INFORMATION BULLETIN

Bulletin No: JC-007-08

430 Steering Valve (23-054) Change

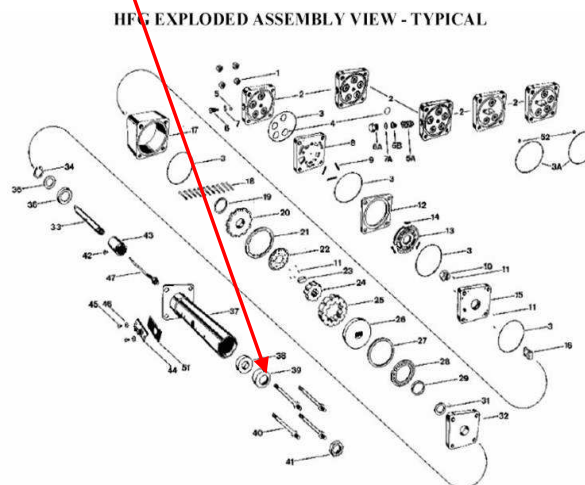
ISSUE: The Parker Steering valve has changed the steering Shaft from $\frac{3}{4}$ " to $\frac{7}{8}$ " which means the original dust seal listed in the parts list (21-402405) will NOT fit the newer steering valves.

CORRECTION: We will update the part breakdown in the near future but in the meantime you will need to make note of the $\frac{7}{8}$ " seal. **The new $\frac{7}{8}$ " seal is part number 21-402407.**

ACTION REQUIRED: Do **NOT** supersede part 21-402405 to 21-402407. They are both good numbers and have separate applications.
